HISTORIC PRESERVATION BOARD

PUBLIC HEARING
30-32 ATLANTIC STREET

TO: Chair Pollard and Members of the Historic Preservation Board
FROM: Rob Wiener, Historic Preservation Compliance Coordinator
DATE: November 12, 2021
RE: November 17, 2021 **PUBLIC HEARING – Final Review of Proposed
Multifamily Residential Infill Construction
HPBR-001790-2021**

Re: 30-32 Atlantic Street, design changes since 10/06/21 HP workshop

① 1st Floor Entrance Plan Detail
1/4" = 1'-0"

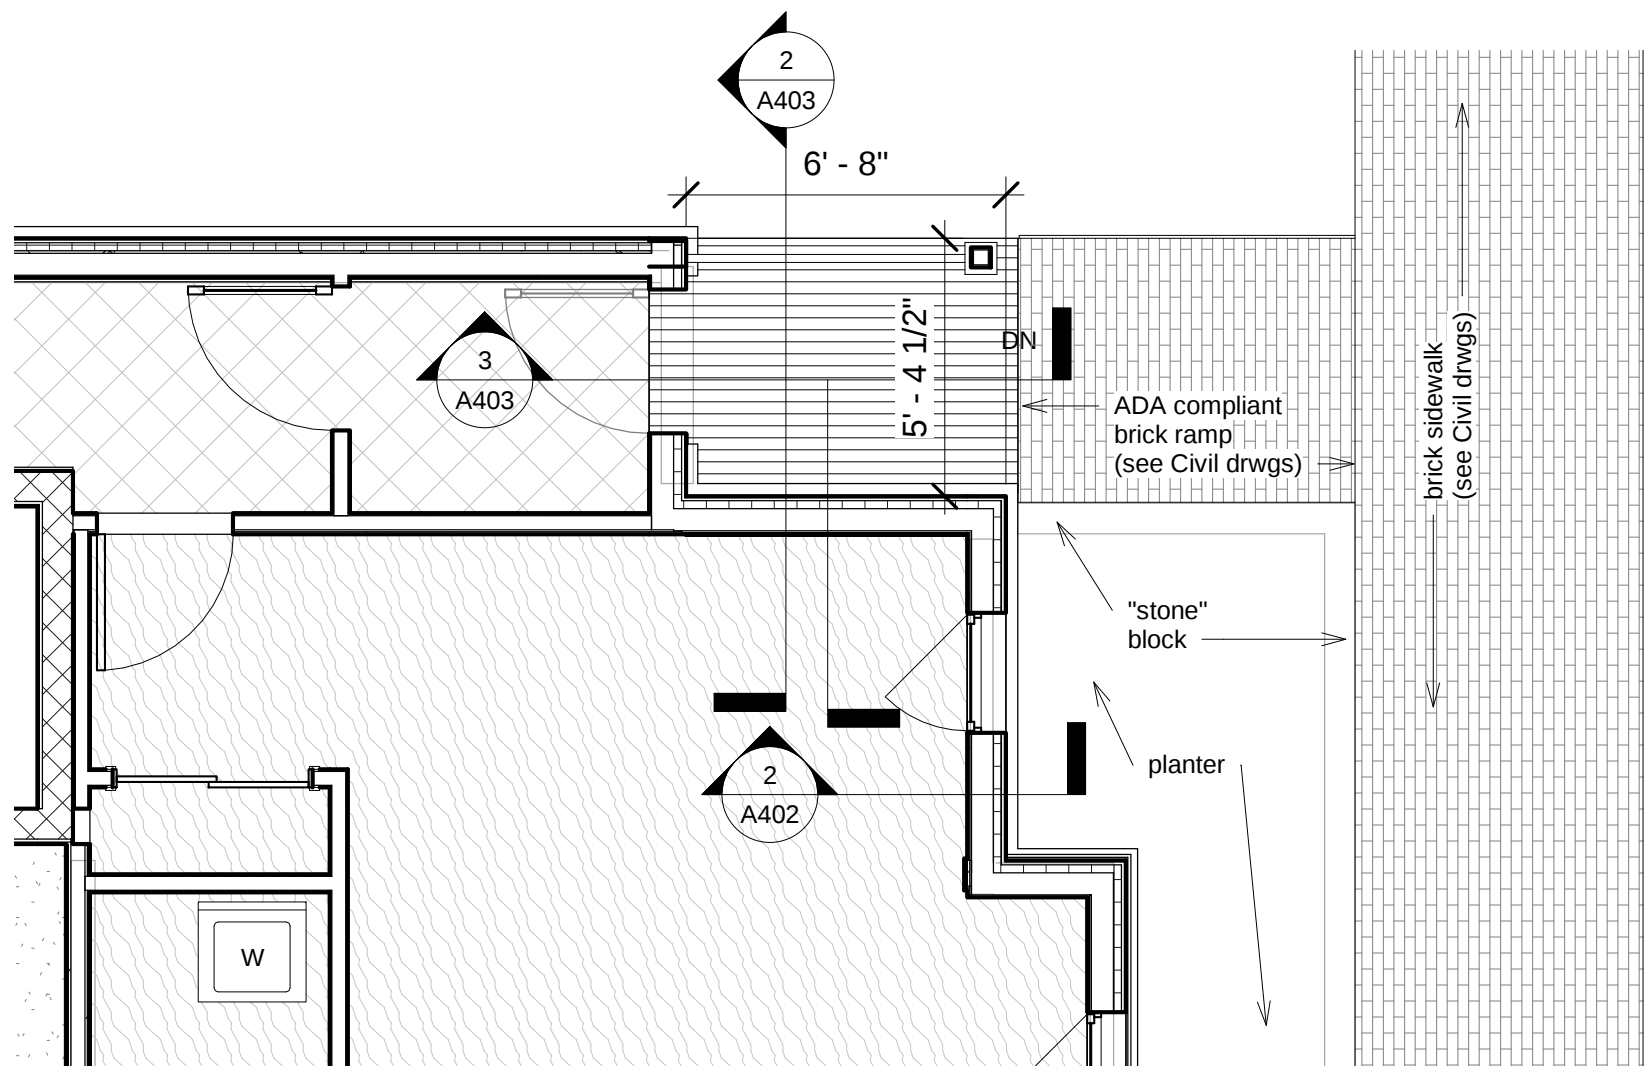
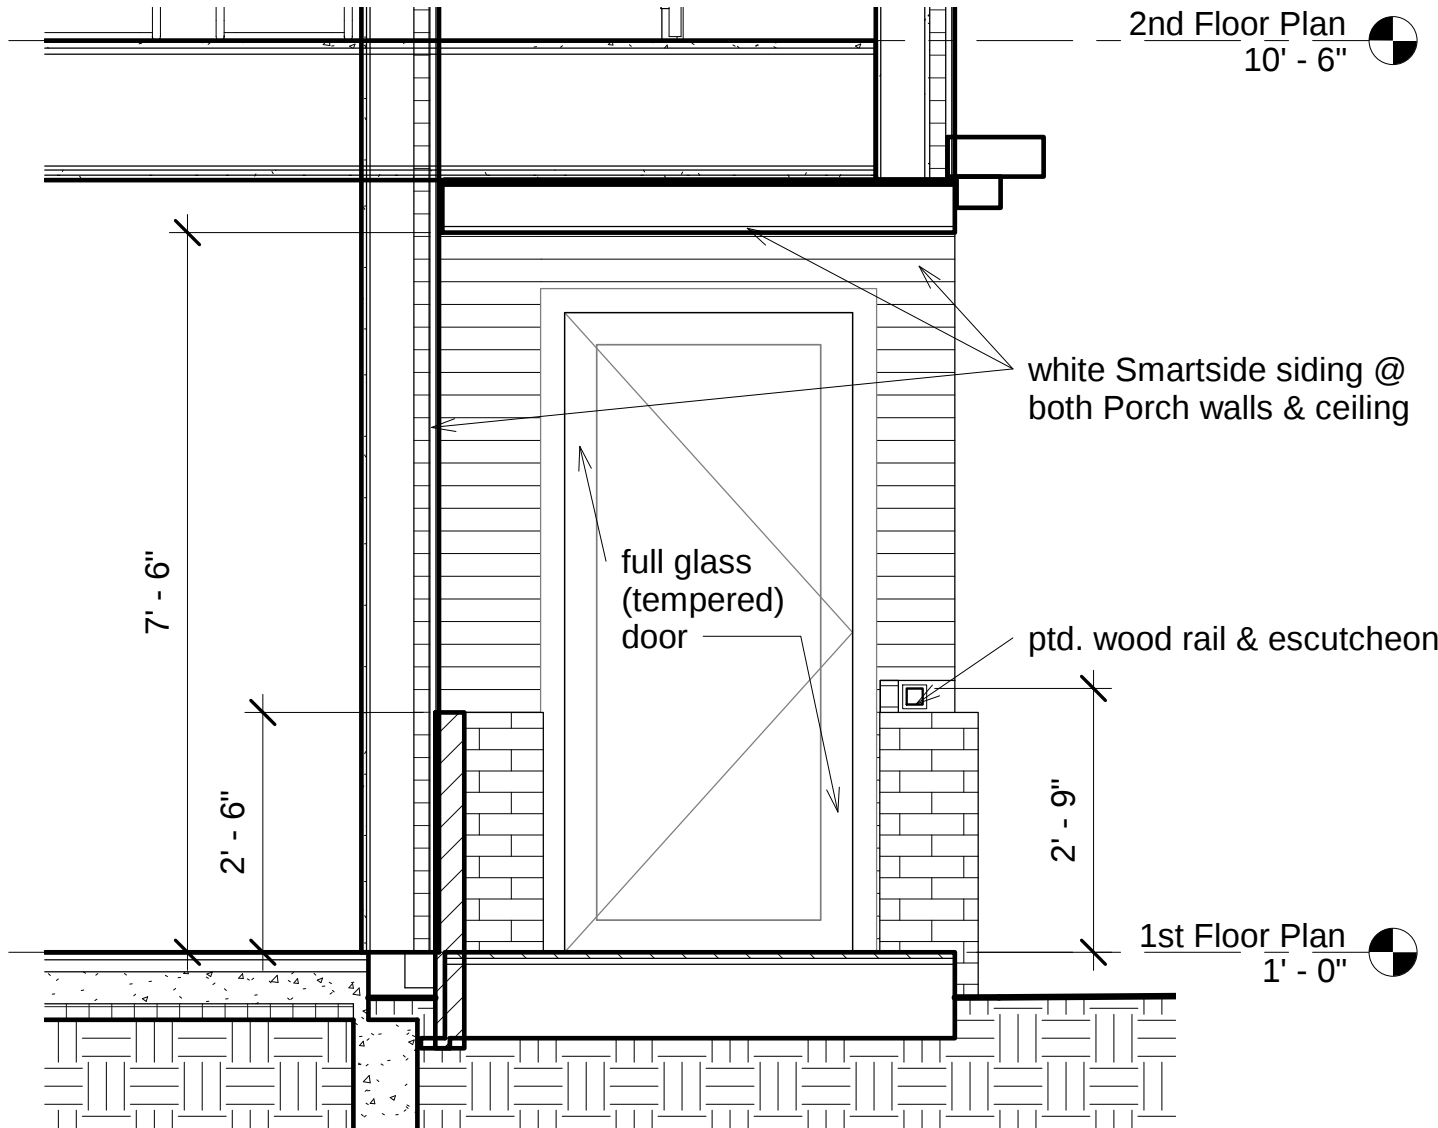
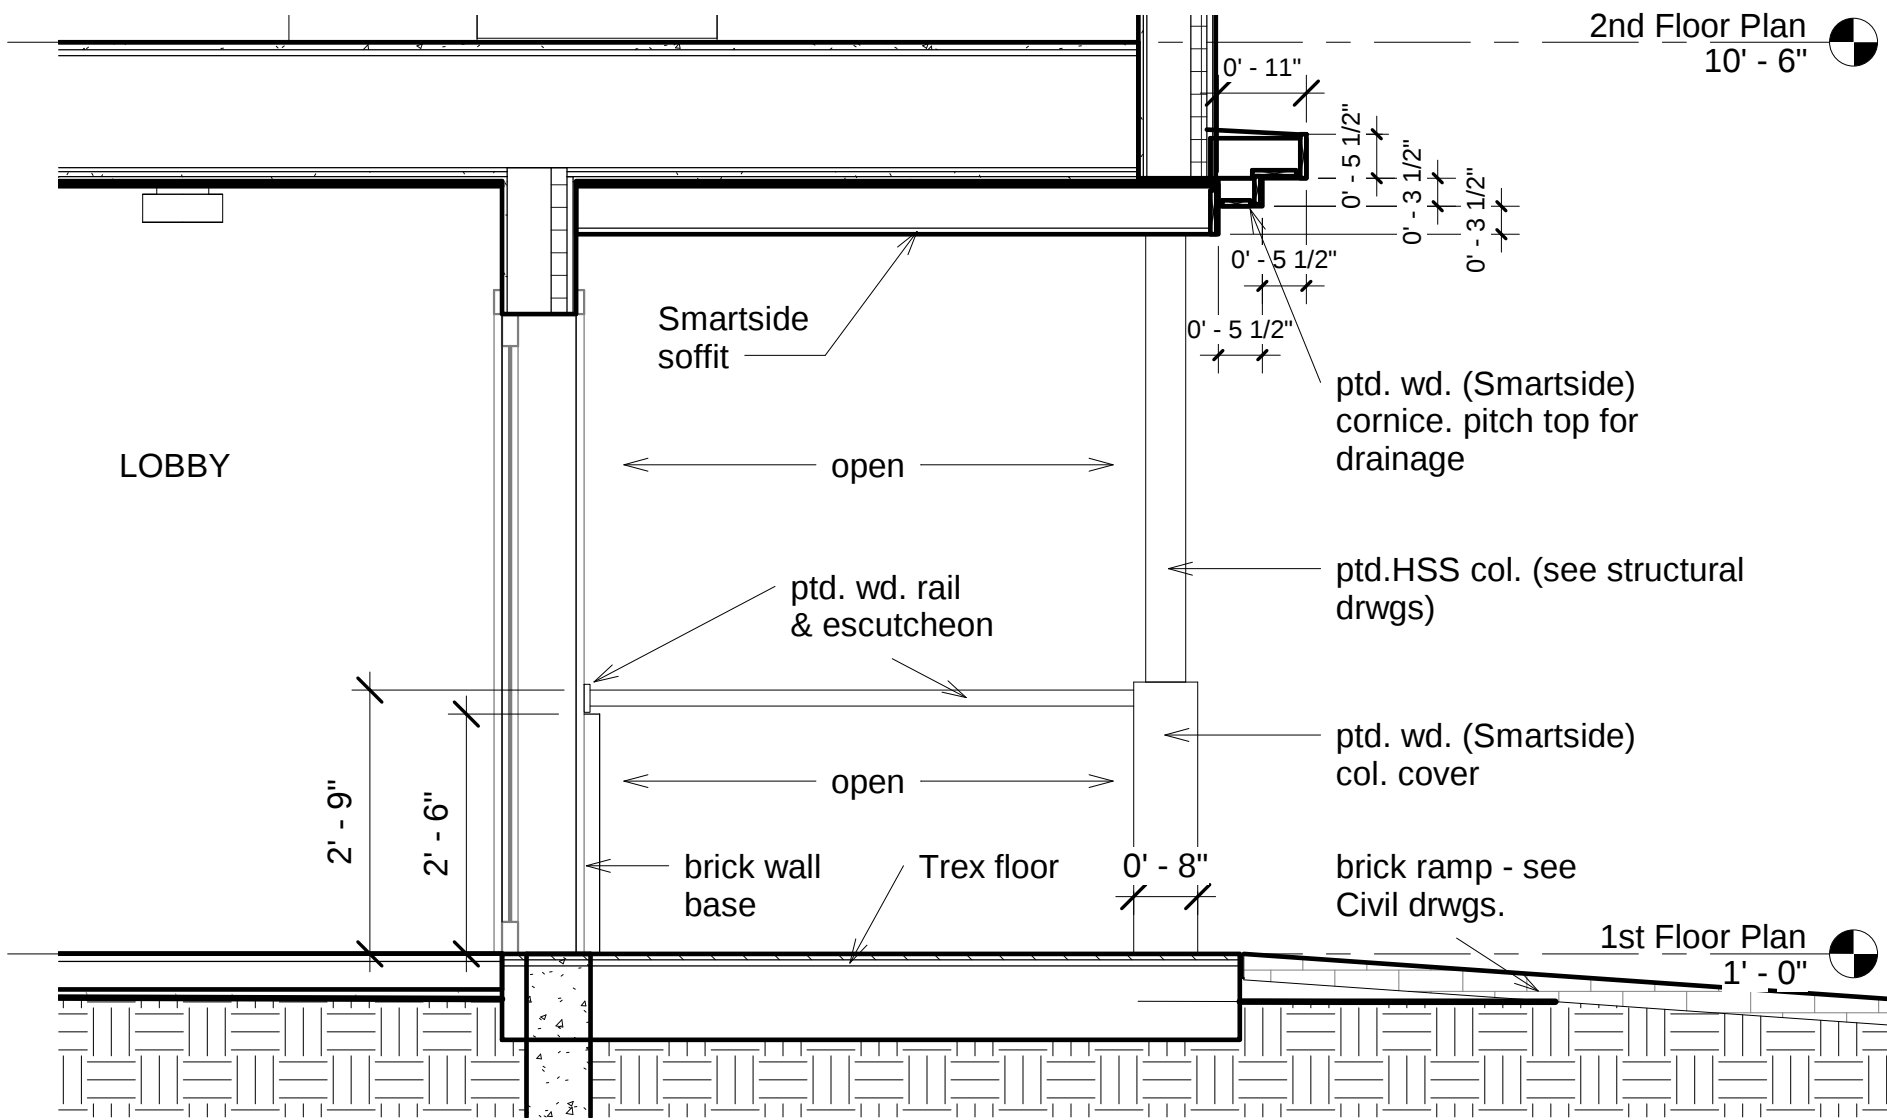
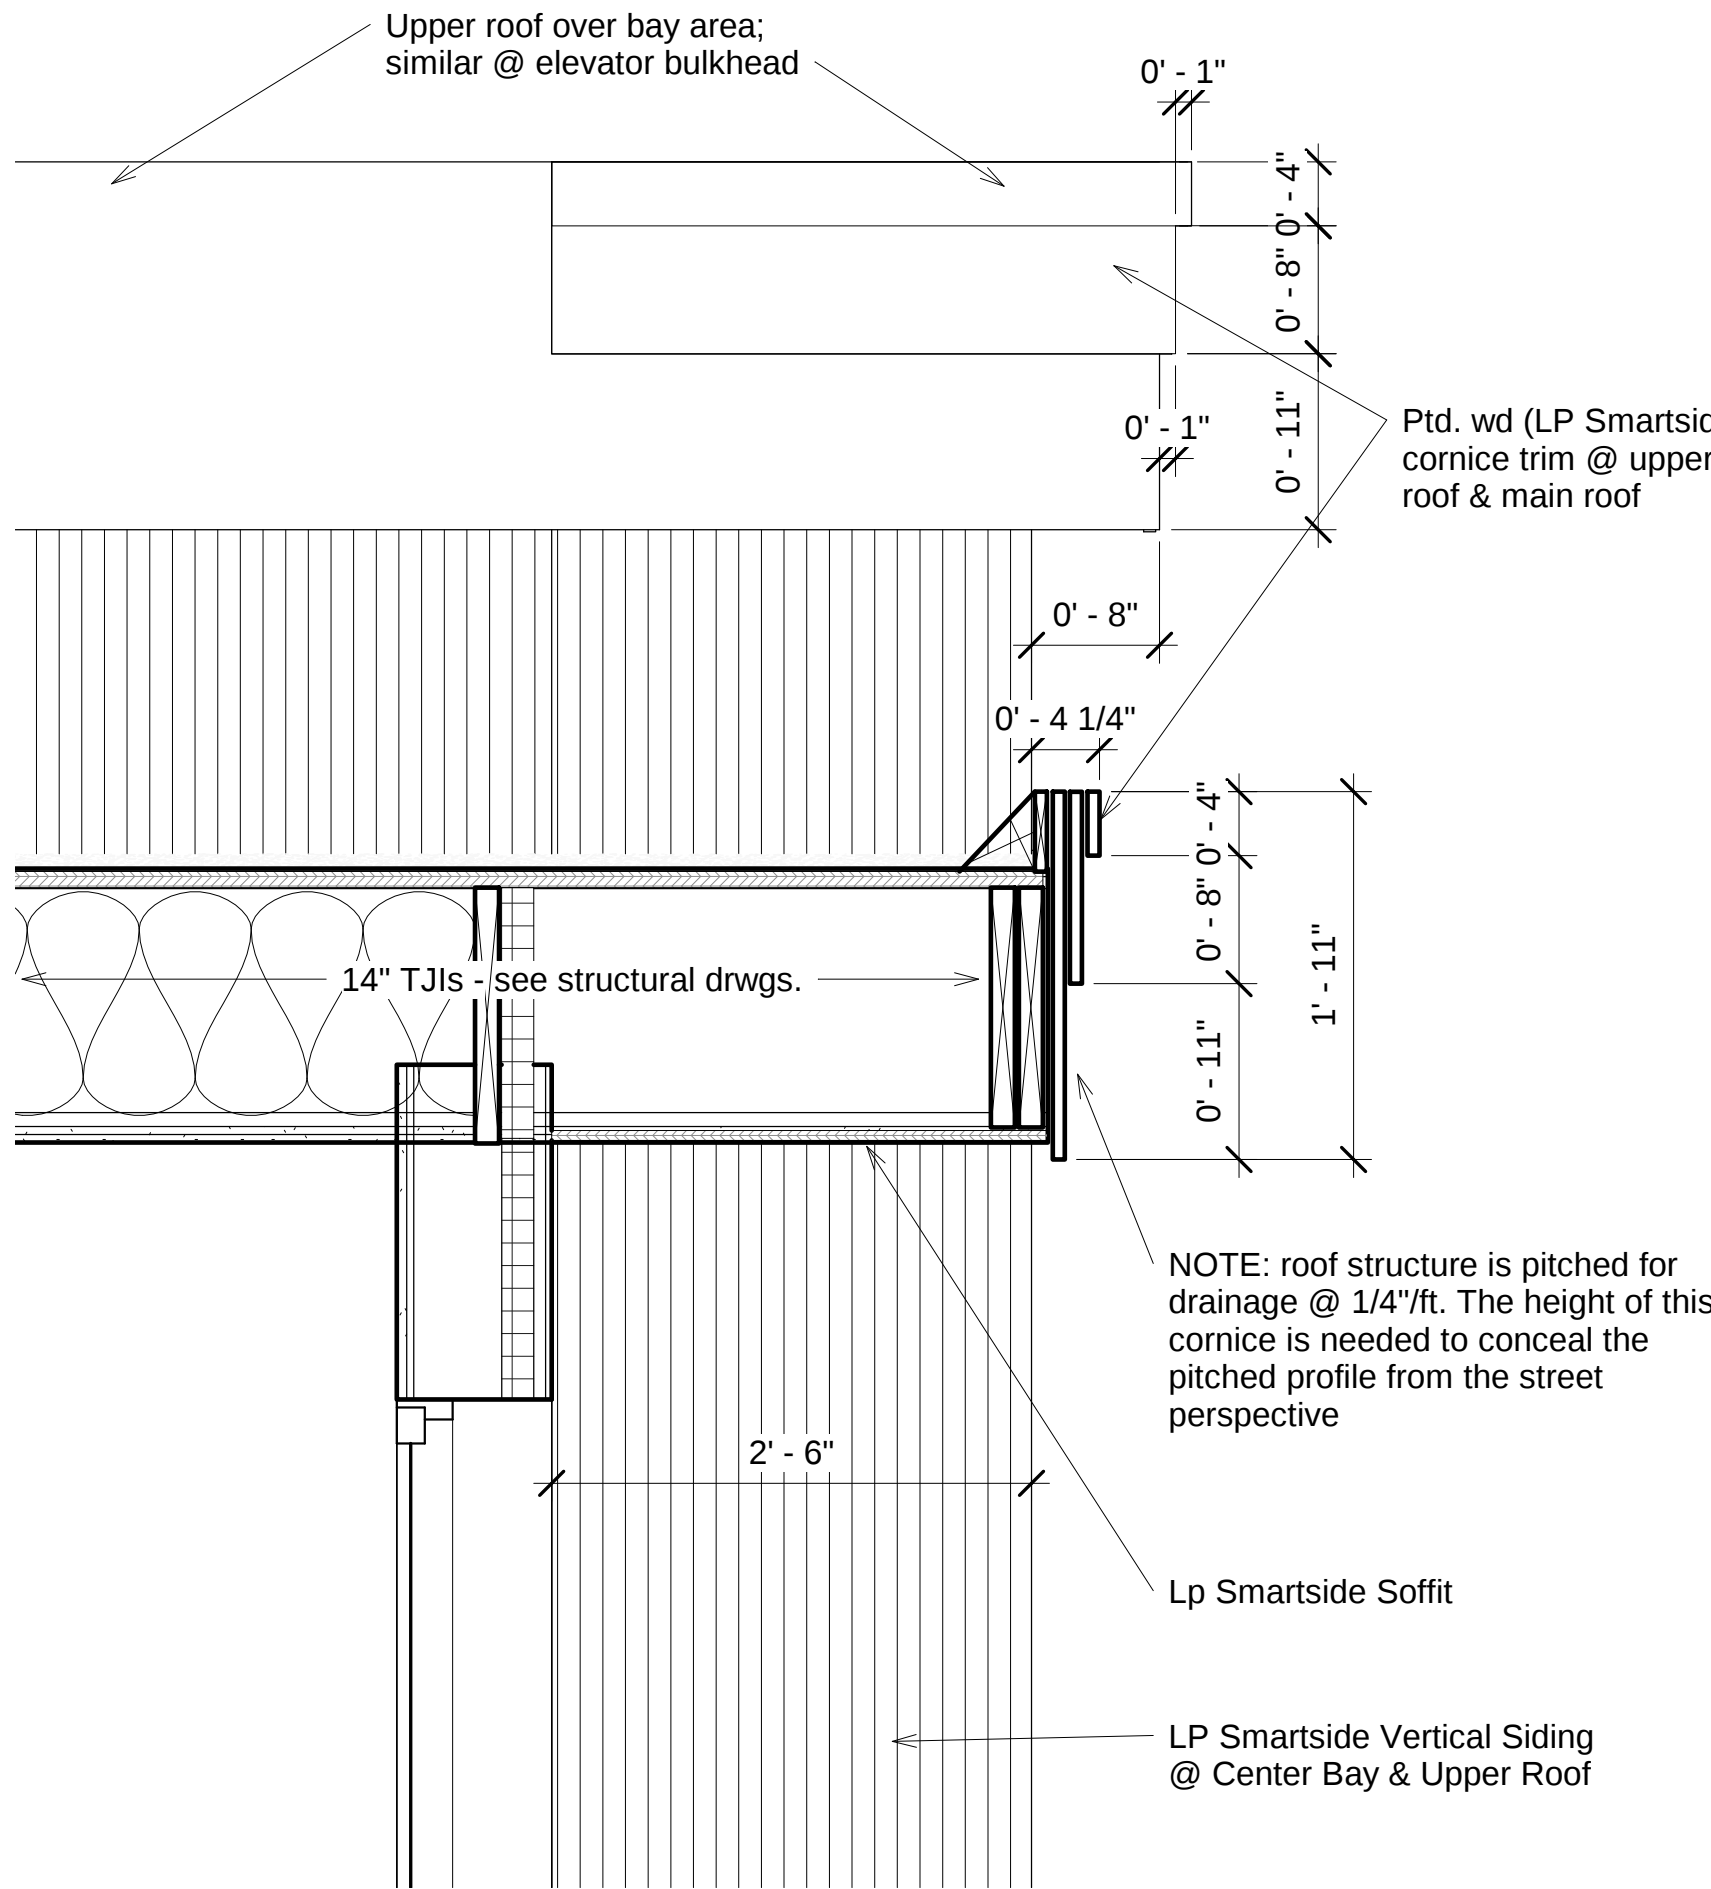
- The front entrance has gained a degree of greater prominence since the workshop. Would it be worth considering giving it greater emphasis? Would a more substantial cornice over the entry help?
- Staff believes that on the front (east) facade the changes to the brick base, the window sizes, the horizontal trim bands, and the front planter have all contributed to a better-balanced composition that more successfully meets the Standards. Do Board members think more should be done to make it a compatible façade?
- On the north and south facades, the contrast between the smaller, single windows and large, mullied units is pronounced when seen in the elevations. On these

1. A new *Drawing, A403*, has been added to provide details at the Front Porch, including general dimensions, the cornice around the porch roof and the railing (in lieu of a solid side wall). As shown in the rendering, we have changed the horizontal siding in this area to white, so that the entrance porch stands out as a brighter element in the overall composition.
